RE: Response Letter 4
Wadleigh Road, Rochester, NH
Tax Map 137, Lot 35-1
JBE Project No. 21137

We are in receipt of comments from Renee Bourdeau, P.E. At Geosyntec dated March 7, 2022. Review comments are listed below with our responses in bold.

RE: Response Letter 5
Wadleigh Road, Rochester, NH
Tax Map 137, Lot 35-1
JBE Project No. 21137

DRAWING No.
C6
 SHEET 9 OF 27
 JBE PROJECT NO. 21137

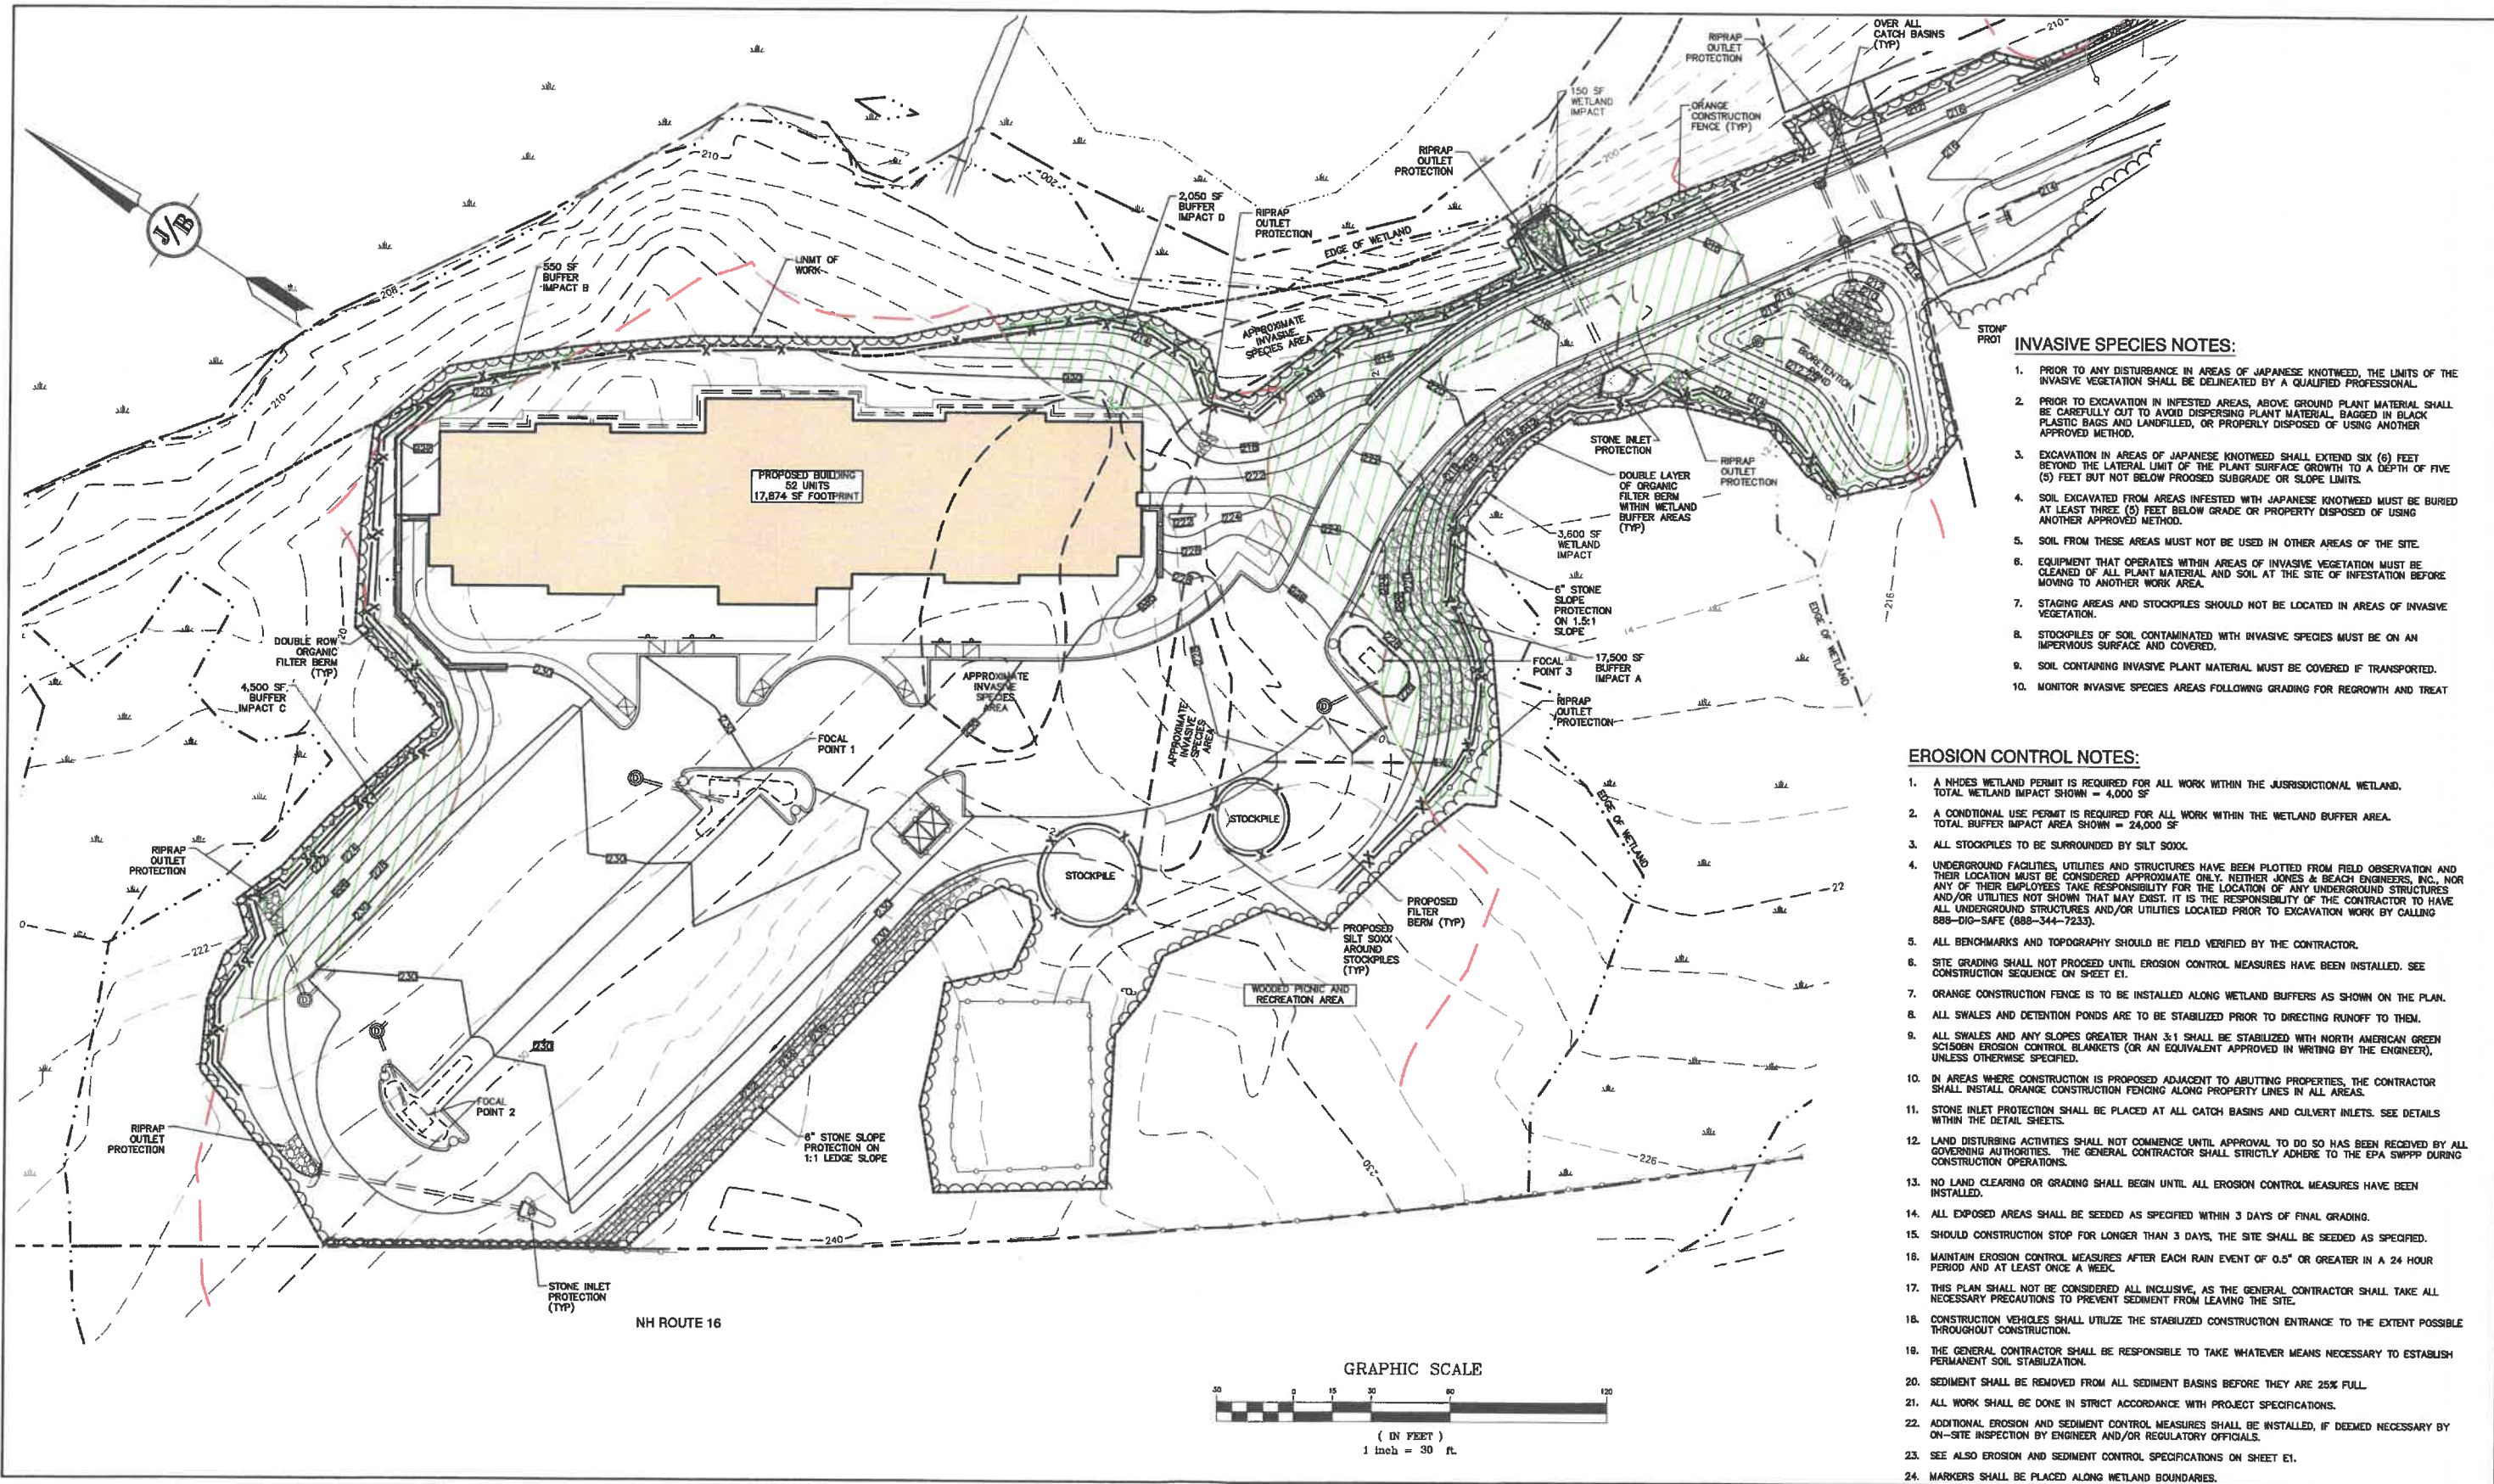
2. *Sheet C-6, additional design is needed to modify grading at the Anchorage Inn entrance. Provide stabilized 2:1 slopes (max) or propose retaining wall to allow widening of Wadleigh in that area.*

RESPONSE: The grading at the Anchorage Inn entrance along Wadleigh Road has been revised to be a 2:1 slope stabilized with rock.

DRAWING No. **U1**
SHEET 11 OF 27
JBE PROJECT NO. 21137

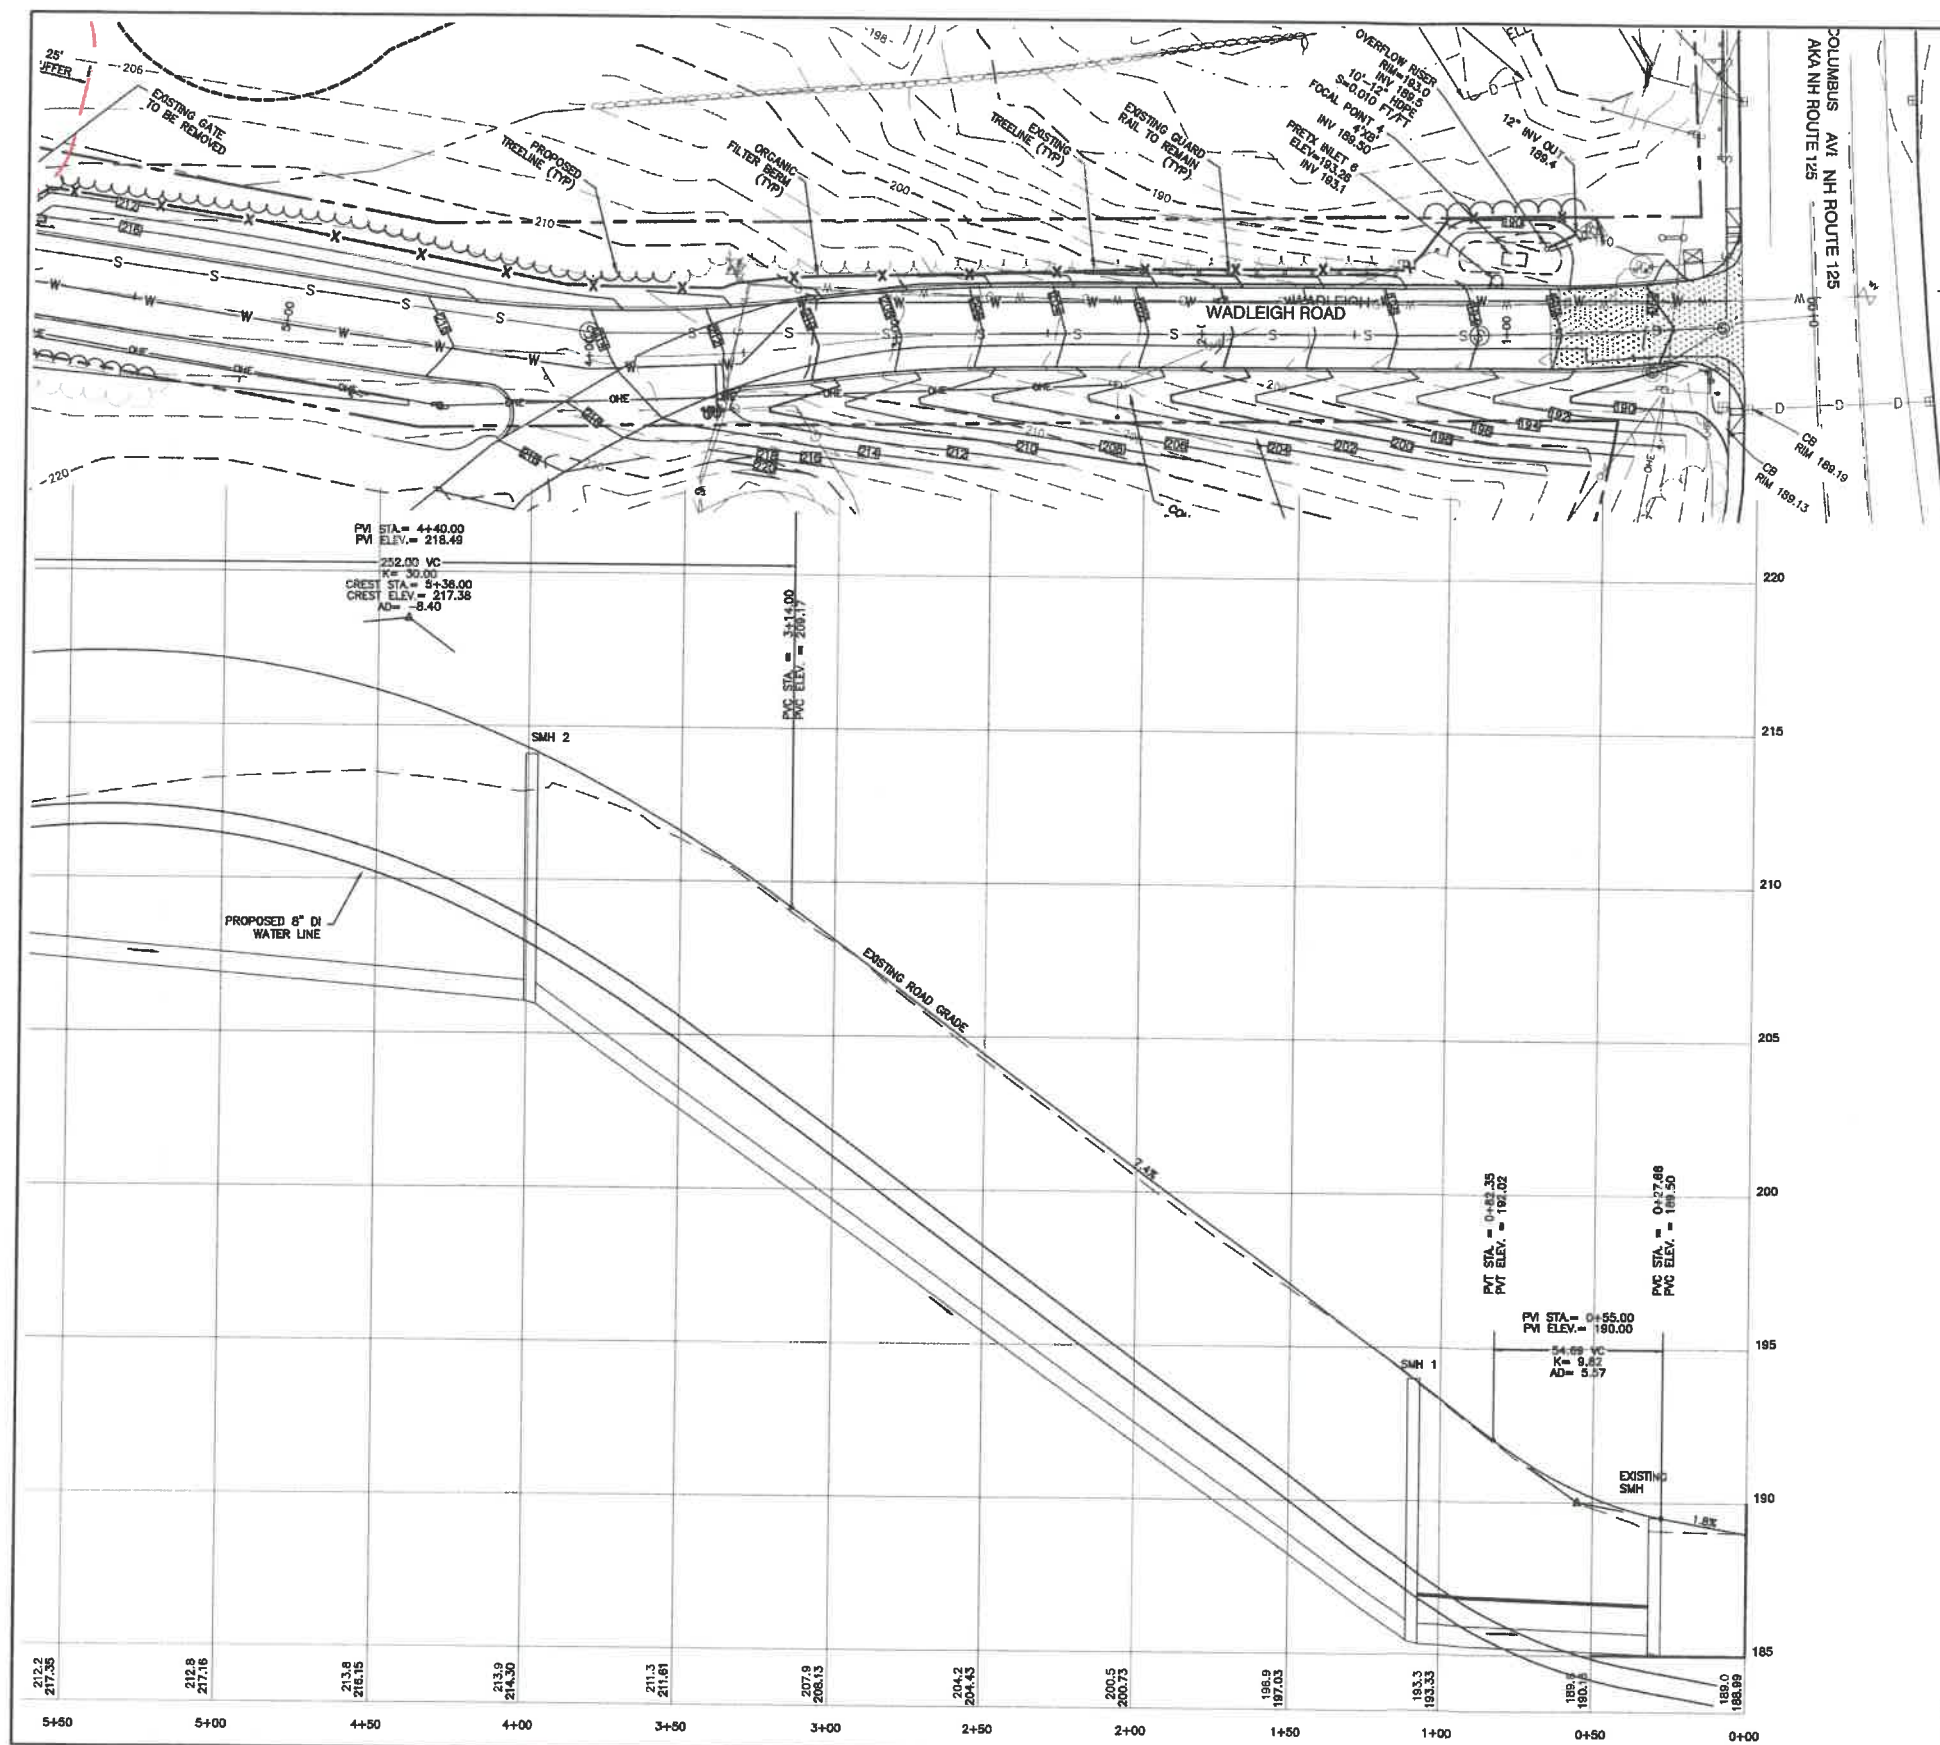
1. *Sheet U-1 add comments that watermain shall be polywrapped and hydrants shall be non- draining, non- rotating stem equal to Kennedy K-81-D. Valves shall open clockwise.*

RESPONSE: The above note has been added to Sheet U1.

DRAWING No. **P2**
 SHEET 14 OF 27
 JBE PROJECT NO. 21137

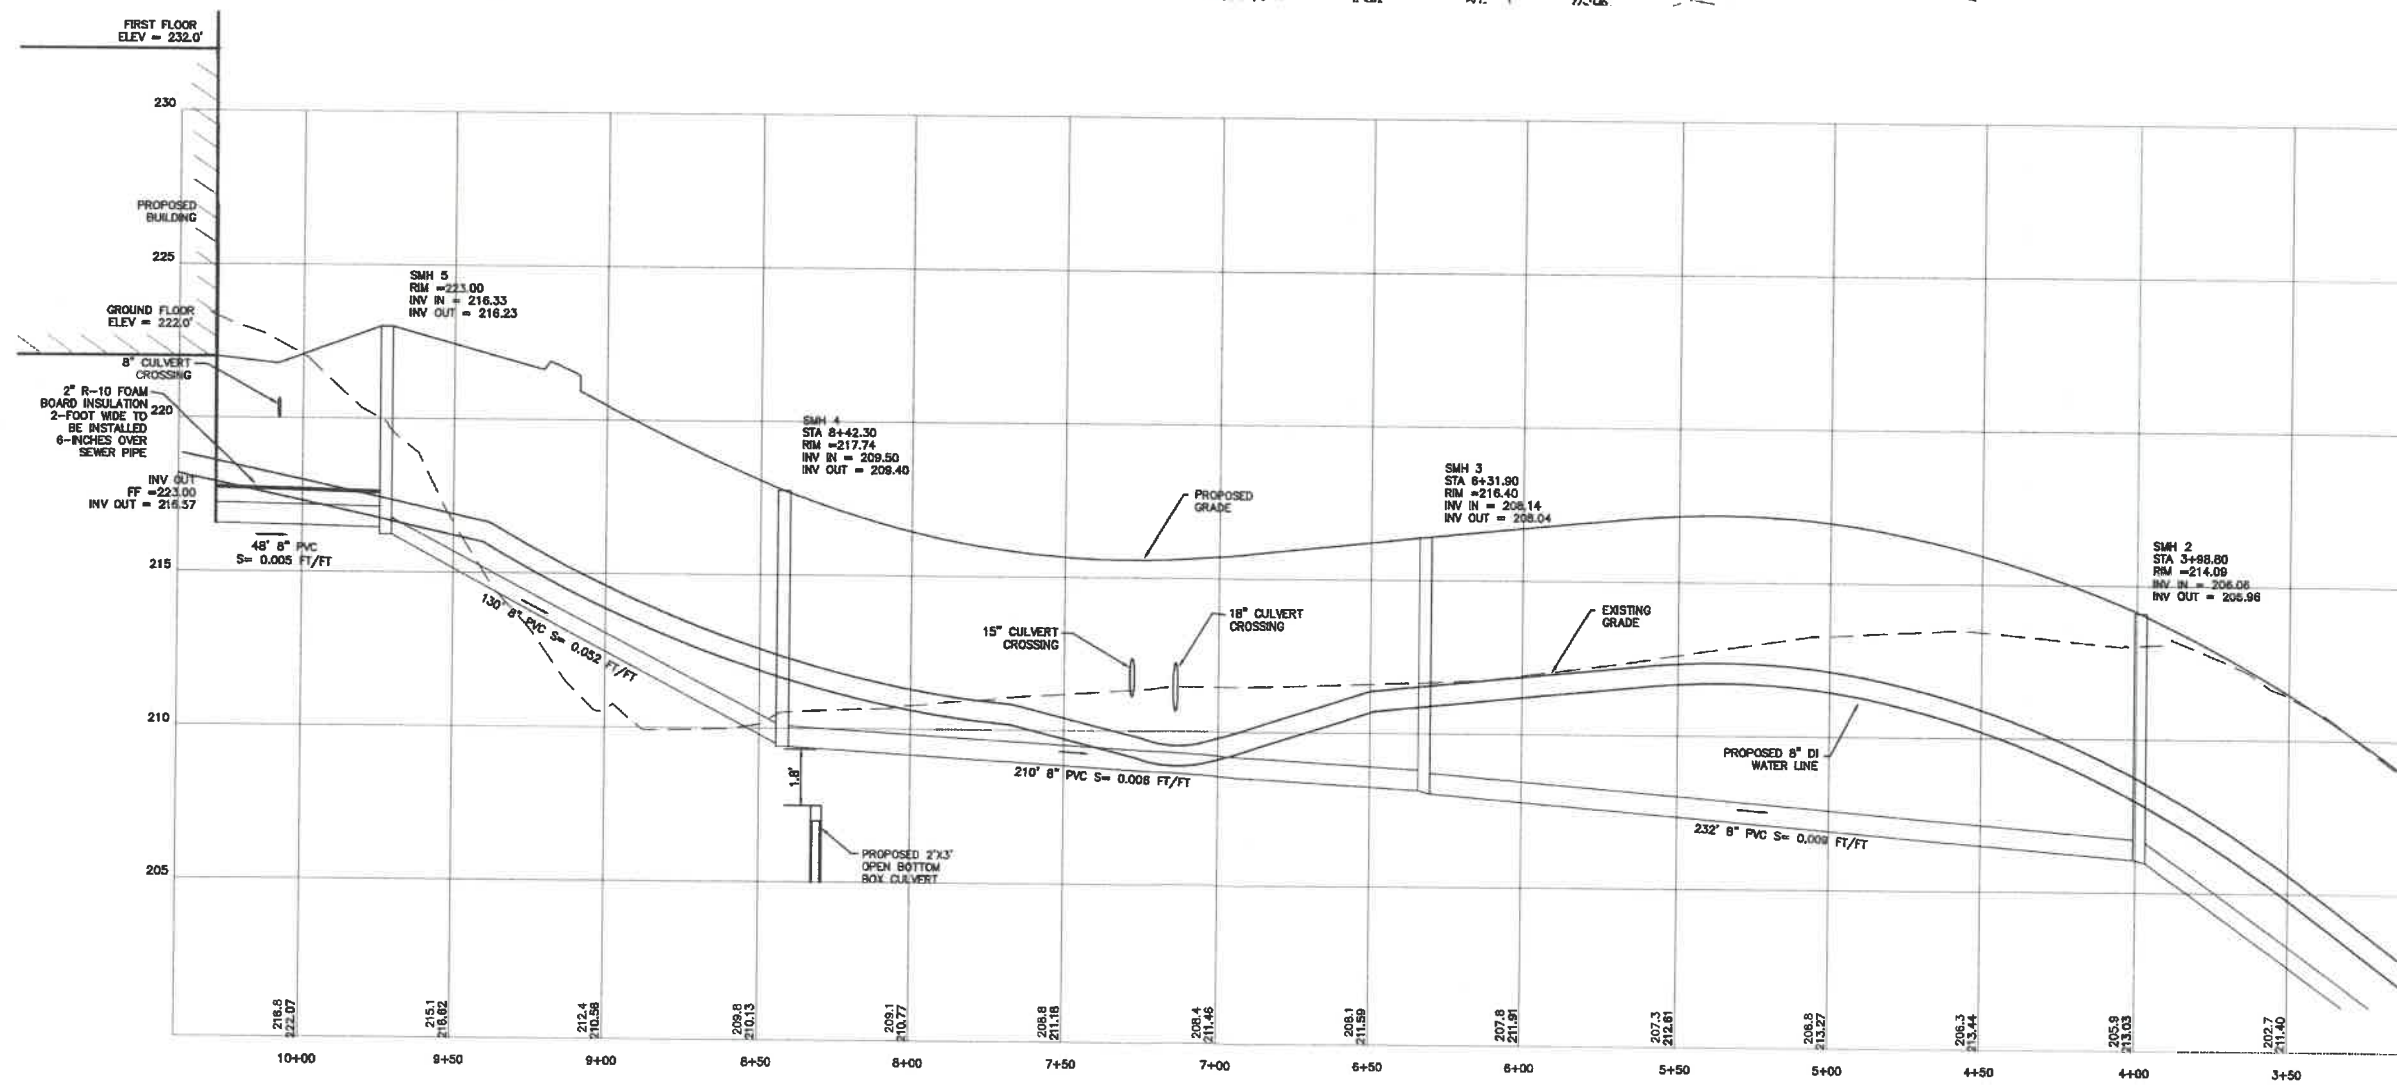
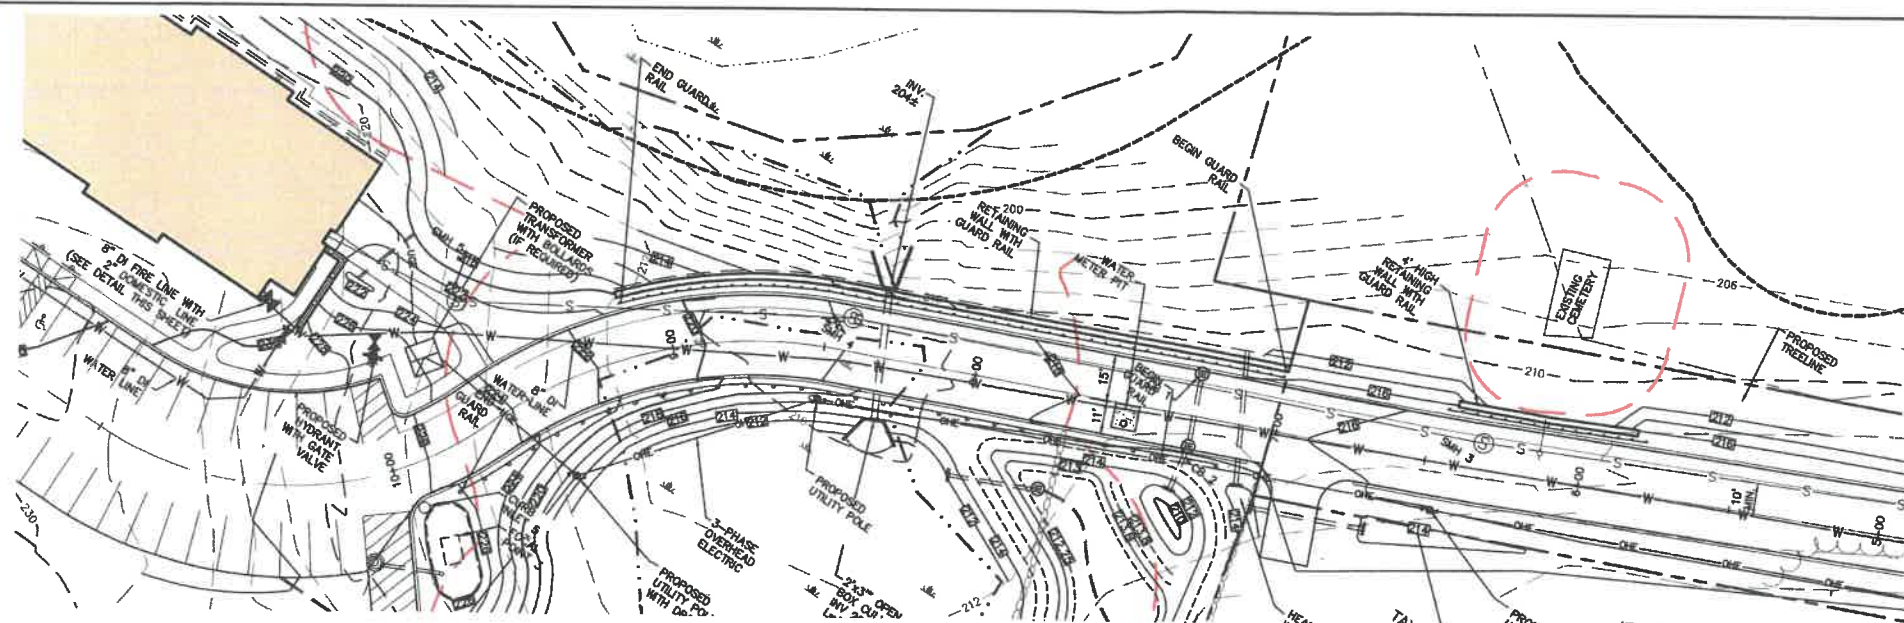
7. *Sheet P2 - Provide a turnaround for City plowing and maintenance vehicles near the end of the improved Wadleigh Rd in City ROW. If located between the two retaining walls, additional retaining wall may be needed.*

RESPONSE: A snow plow turn around has been added along Wadleigh Road within the City ROW adjacent to the site's bioretention pond.

DRAWING No.
L3
 SHEET 18 OF 27
 JBE PROJECT NO. 21137

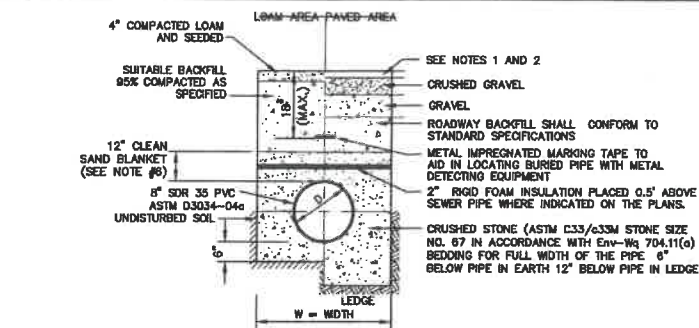
6. *Sheet L3 - Lighting in the City ROW on Wadleigh Rd should be cobra head fixture mounted on utility pole, not freestanding lamp post. Reduce the number of street light locations from two to one in the City ROW.*

RESPONSE: Street lines within the City ROW have been eliminated. The proposed lighting begins on the site.
